# DeKalb County Historic Preservation Commission

## Staff Report

- A. 1073 Oakdale Road, Dan Hanlon. Modify a previously approved COA to renovate a carriage house. **1247404**

# PROPOSED RENOVATIONS TO THE JONES AND CLEVELAND CARRIAGE HOUSE

LEFT SIDE ELEVATION  
SCALE: 1/4" = 1'-0"

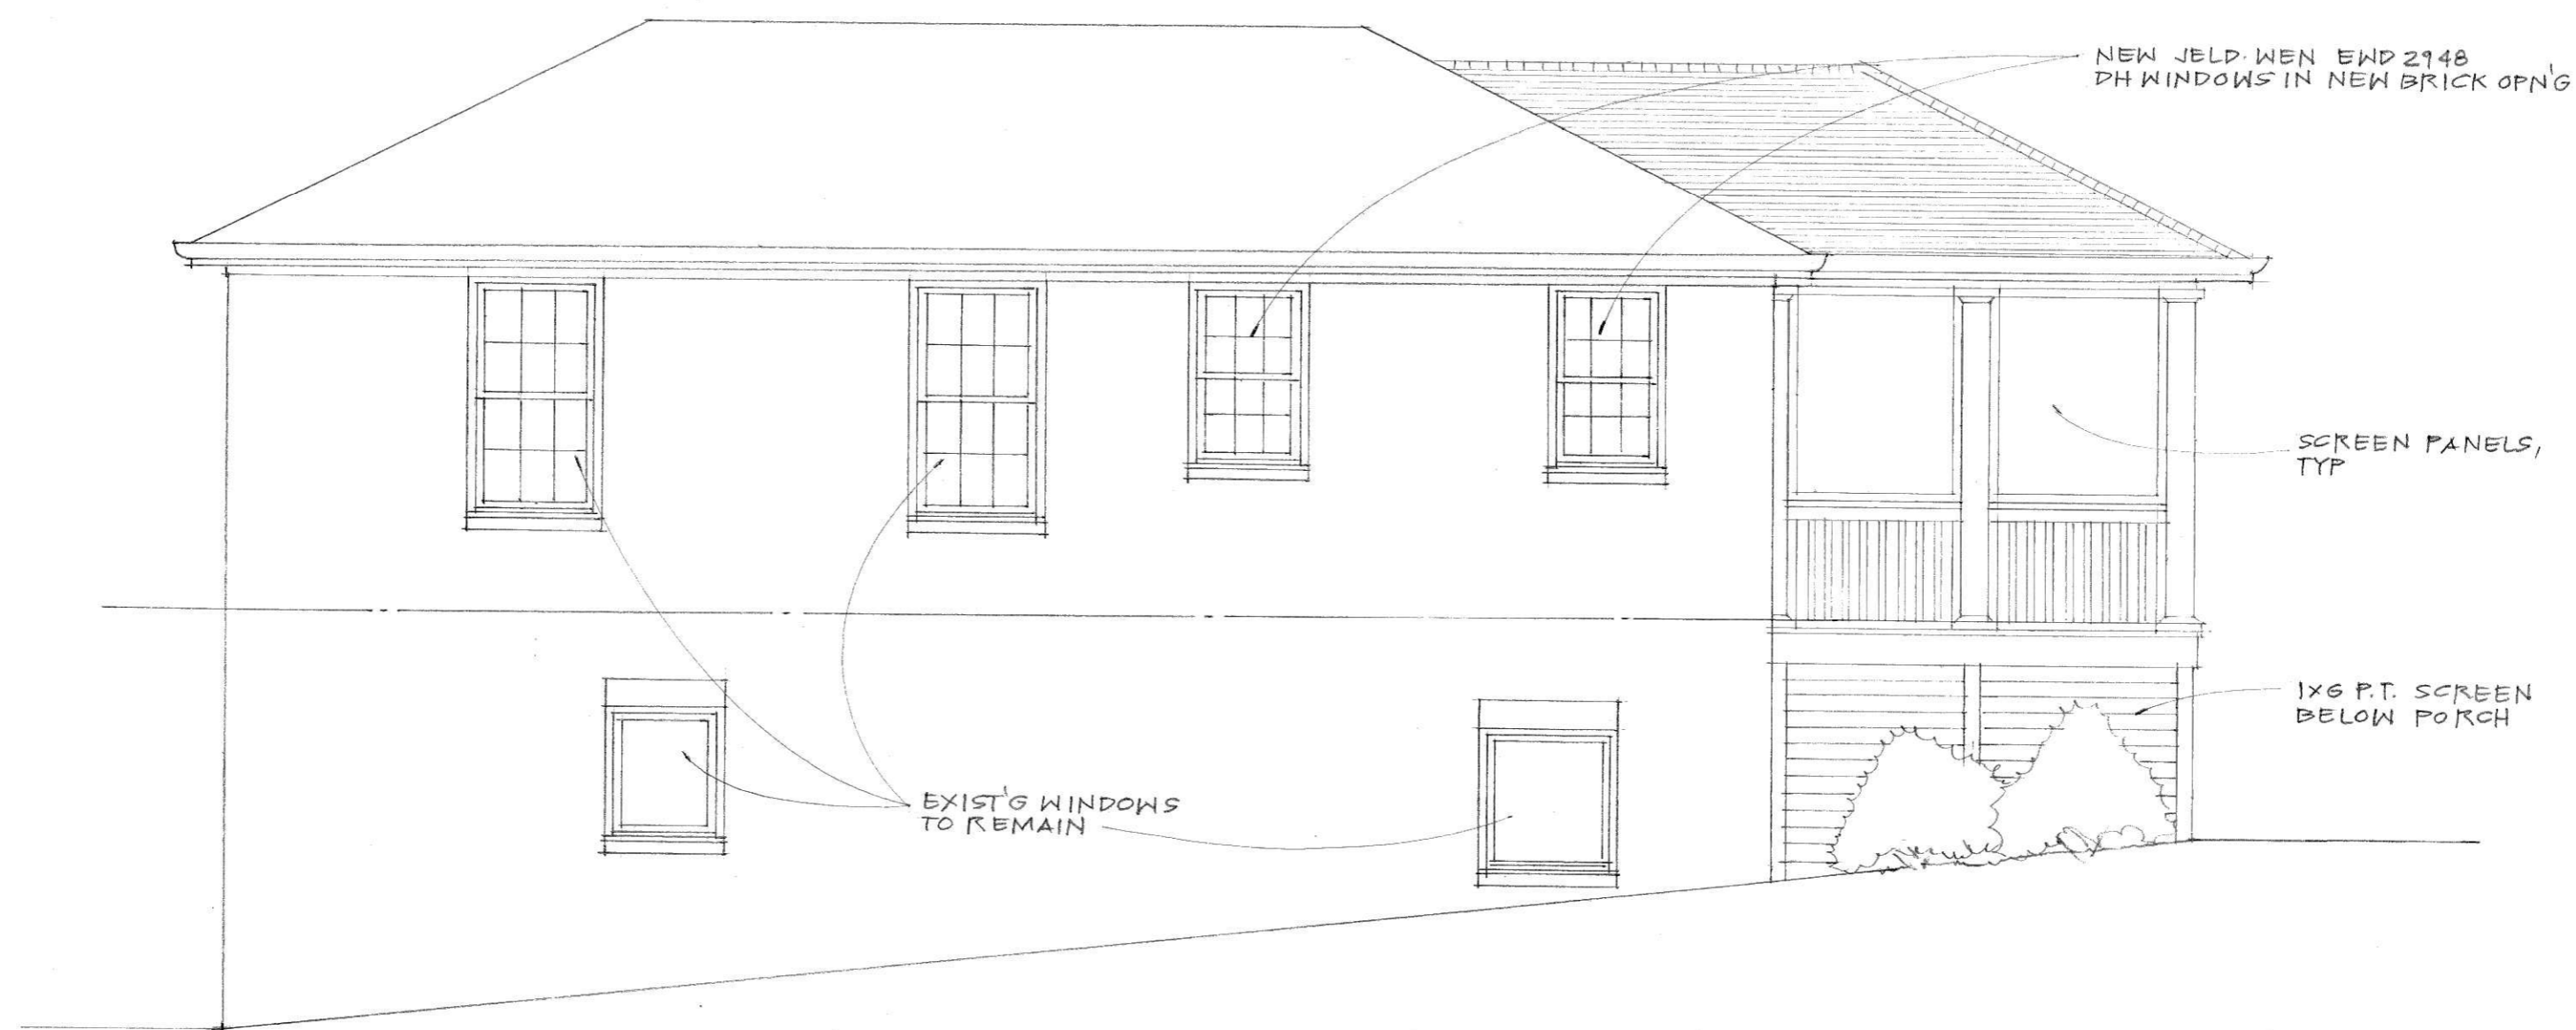
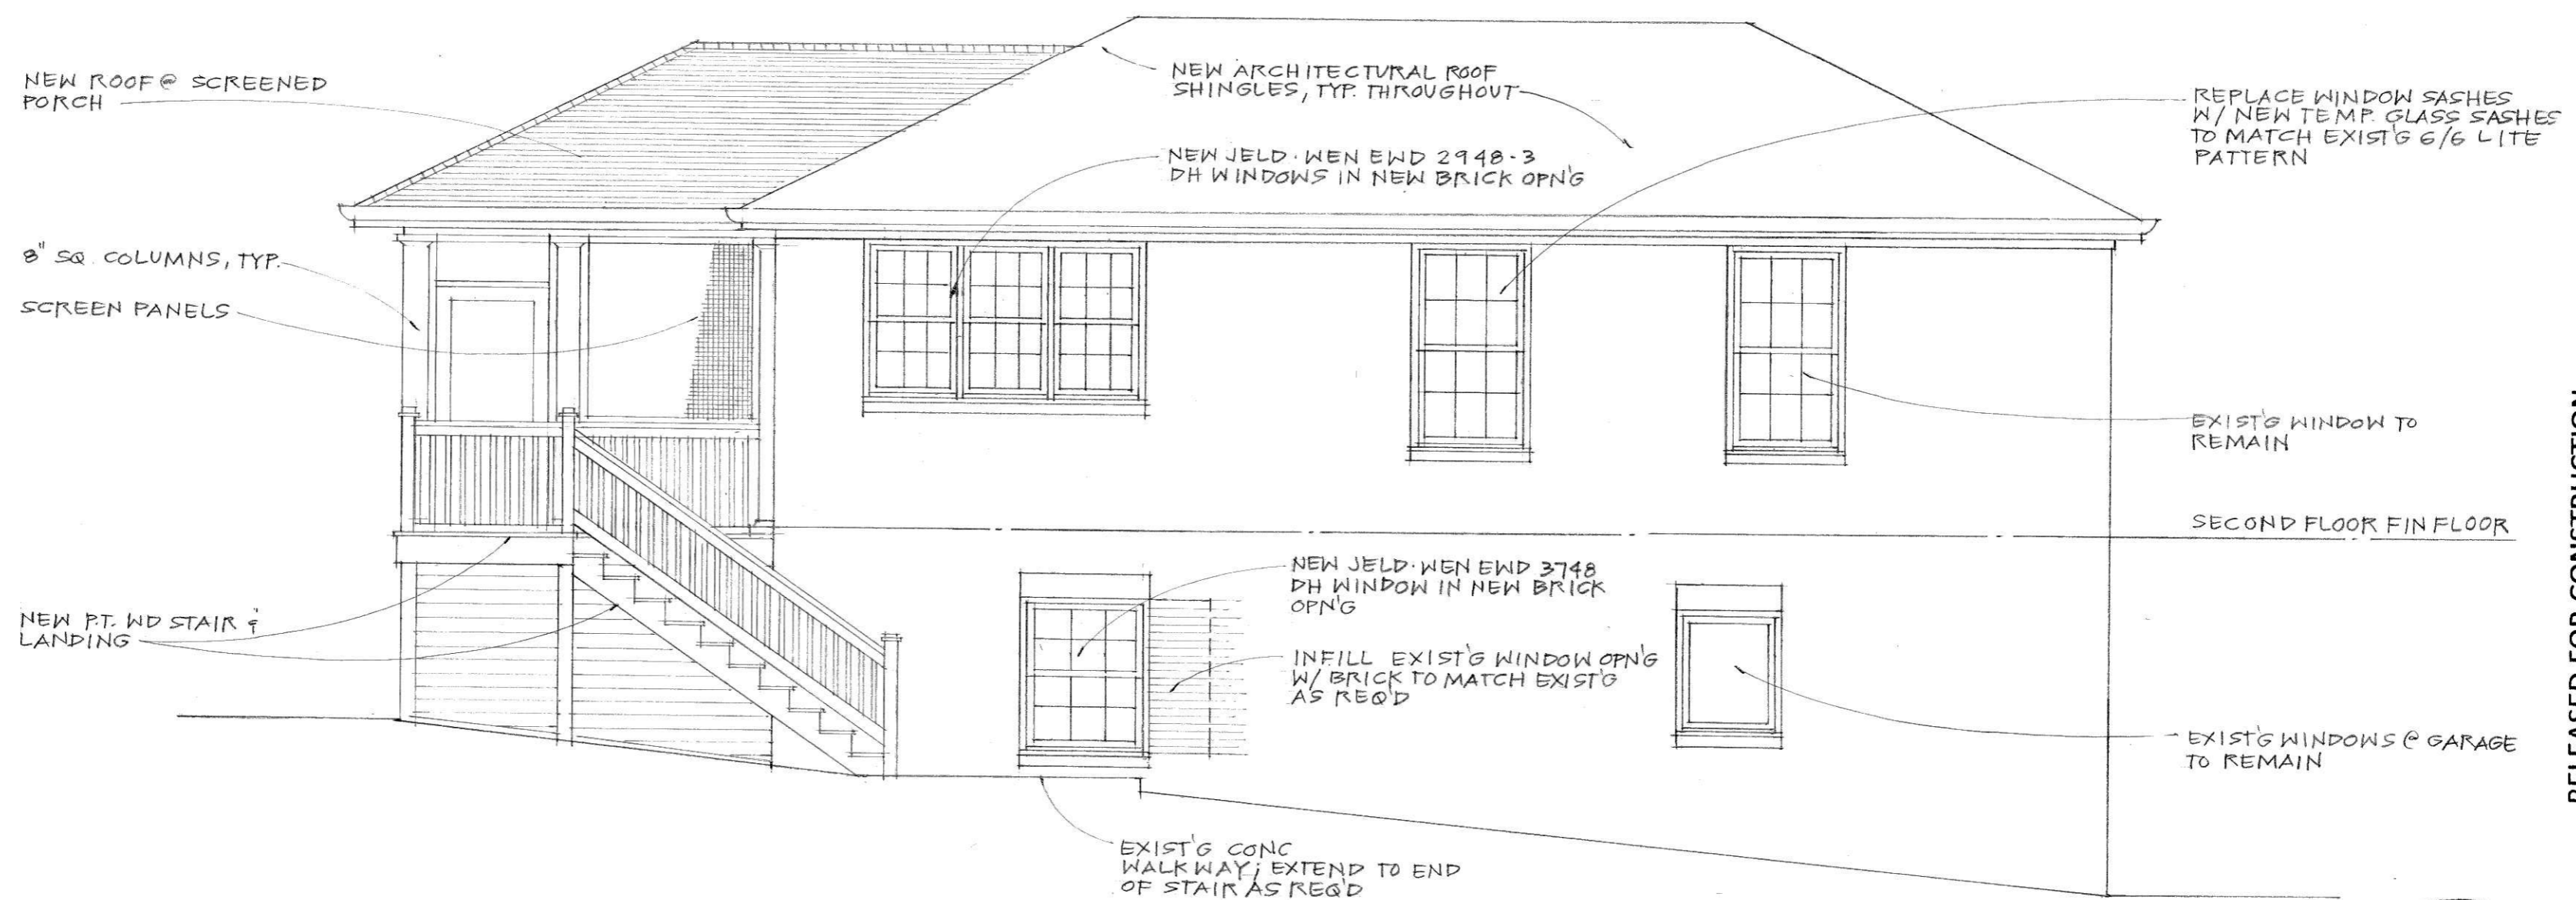
1. Modify windows on the left-side elevation. The previously approved 12-pane sliding-transom window on the upper story of the left elevation of the carriage house will be modified to a set of three double-hung windows with 6-over-6 divided lite panes. The original single-pane casement window on the lower story of the left elevation will be removed and replaced with a double-hung window with 6-over-6 divided lite panes.

**Approve.** The proposed changes do not appear to have a substantial adverse effect on the property or the district. This application appears to meet the guidelines and the staff recommends approval.
